Our Ref: OG CS1806.02272
Your Ref: RFI-0777

Contract CN-8766
RNAU - Main Contract
RFI-0777 Amended Balance Response – Size discrepancy for SW Pit 8 and 9/230
Proposed Variation VAR-077 – Modified design for SW Pit 8 and 9/230

MODIFIED ROOF SLAB - PLAN

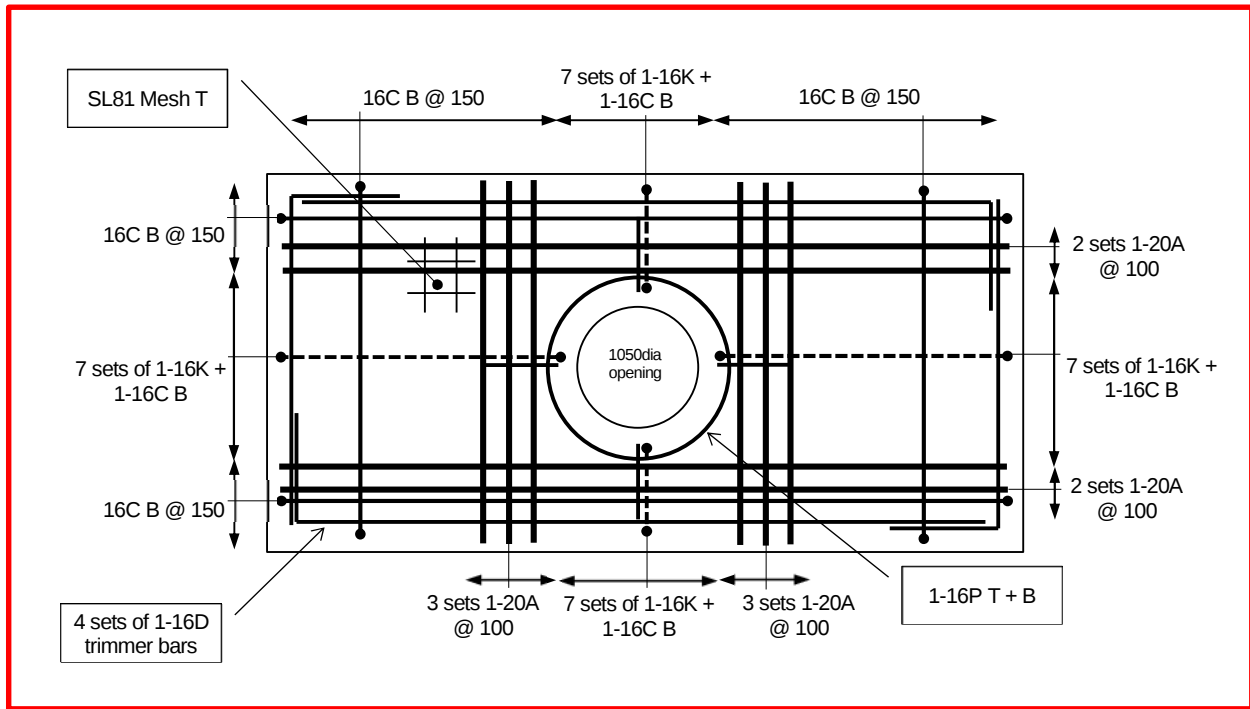
As per RFI-0745 there are pit discrepancies on Line 230, specifically pits 9/230 and 8/230. There is a high possibility the precast pits will be damaged in transport and unloading due to their size, the large voids which will be needed and the shallow remaining sections of the pits.

Miscellaneous Structures Drawing 780225 and 780226 (attached) detail special drainage chamber 15/160. We propose to pour insitu chambers in accordance with this design and reinforcement detail, however, adjust the chamber so it is appropriate size.

Pit 9/230: Due to the angle of the outlet RCBC a 2500mmx1500mm (Internal Diameter) chamber is proposed (attached drawing).

Pit 8/230: As the inlet and outlet of these RCBC do not have an angle a 2400mmx1500mm (Internal Diameter) chamber is proposed (attached drawing). We request confirmation if we can proceed.

1. *"The proposed construction method for pits 8 and 9 is approved.*
2. *Floor and Walls reinforcement as per design details prescribed for SW Pit 15/160 (DWG 780225 and 780226).*
3. *Roof Slab reinforcement as per design details prescribed for SW Pit 15/160 (DWG 780225 and 780226) with additional reinforcement as shown below:"*
